# Providence City Plan Commission

## AGENDA ITEM 2 ■ 195 NELSON STREET / RFK SCHOOL

### OVERVIEW

Site plan with parking and landscaping

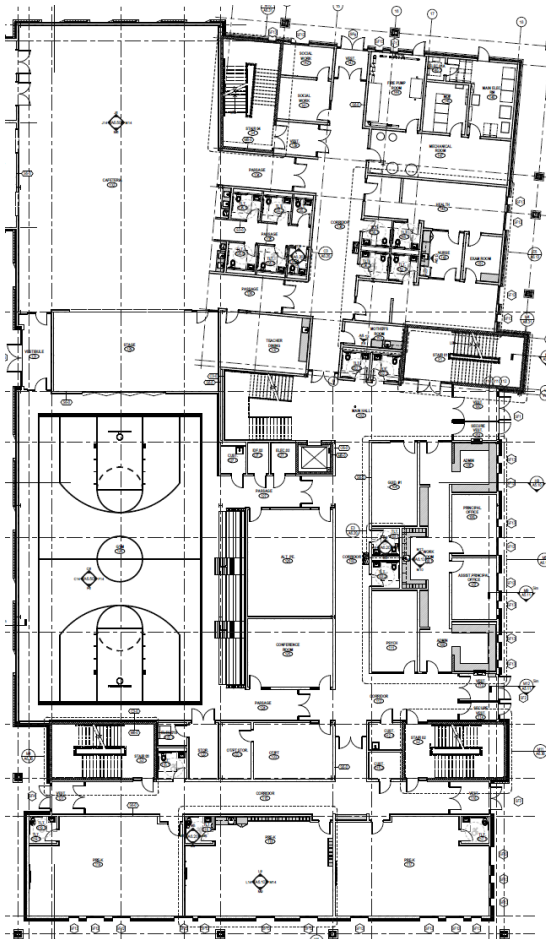
Sixteen parking spaces are needed to meet the requirement of one space per three employees with 46 employees expected. The applicant will meet the parking requirement, providing a total of 39 standard spaces in the parking area. Drop-off areas will be provided on Jastram, Eaton and Nelson Streets. A total of 104 bicycle parking spaces will be provided on the corners of Jastram and Eaton Streets fulfilling the requirement of 3 spaces for each of the 49 classrooms.

The PS zone requires 30% of canopy coverage for a lot size of approximately 70,000 SF amounting to approximately 21,000 SF. The applicant will meet this requirement by planting large and medium trees around the perimeter of the site on the Eaton, Nelson and Jastram Street frontages, and within the parking lot.
